During some initial testing with the TPS65987D we found what appears to be an error in the datasheet.

Figure 32. I²C Address Divider

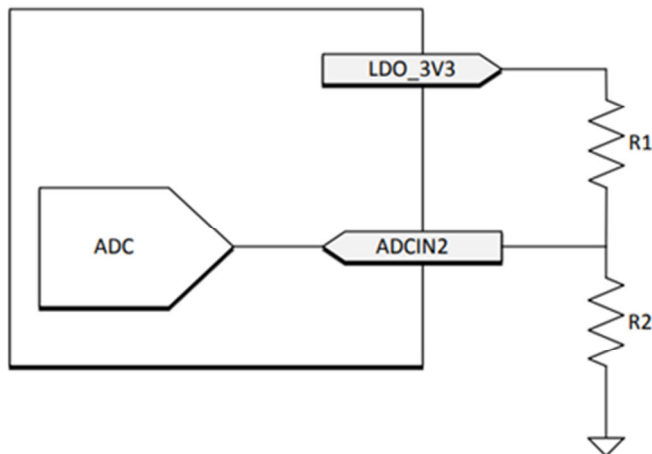
Based on our testing though, I2C2 is behaving as I2C1 from an address perspective.

If "ADCIN2" is 3.3V I2C2 ACK's at 0x23,
If "ADCIN2" is 0.0V I2C2 ACK's at 0x20.

This is what I would expect if we were interfacing to I2C1.

But since we are connected to I2C2, ADCIN2 should have no effect on I2C2 address, which based on the table should be fixed at 0x38.
